PRODUCT/PROCESS CHANGE NOTICE (PCN)

PCN #: A0705-01	DATE: 6/11/2007	MEANS OF DISTINGUISHING CHANGED DEVICES:
Product Affected: Ceramic DIP, Sidebraze and Topbraze of 28 leads or more (Refer to Att. II for affected part numbers)		<input type="checkbox"/> Product Mark <input type="checkbox"/> Back Mark <input type="checkbox"/> Date Code <input checked="" type="checkbox"/> Other
Date Effective: 9/11/2007		Shipment starting from 9/11/2007

ATTACHMENT I - PCN #: A0705-01

Figure 1: Existing material - Silicon bump

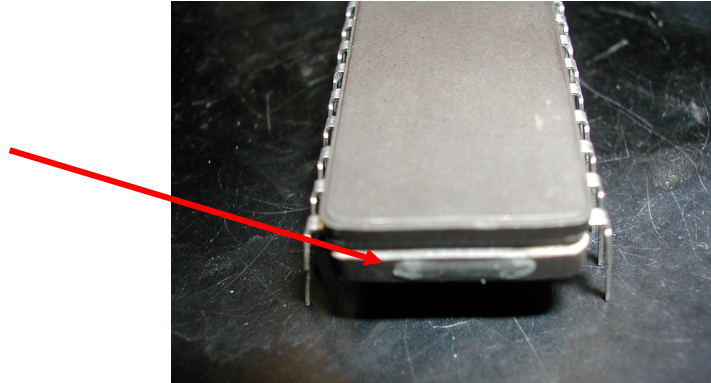
PCN Type: Assembly Material Change
Data Sheet Change: None
Detail Of Change: This notification is to advise our customers that there will be a change of material from silicon bump to bumper tape, which is applied at the package end (opposite pin 1) to prevent package crack or chip as a result of knocking between units.

Description	Existing Material	New Material
Material	Silicon bump	Bumper tape

Figure 2: New material - Bumper tape
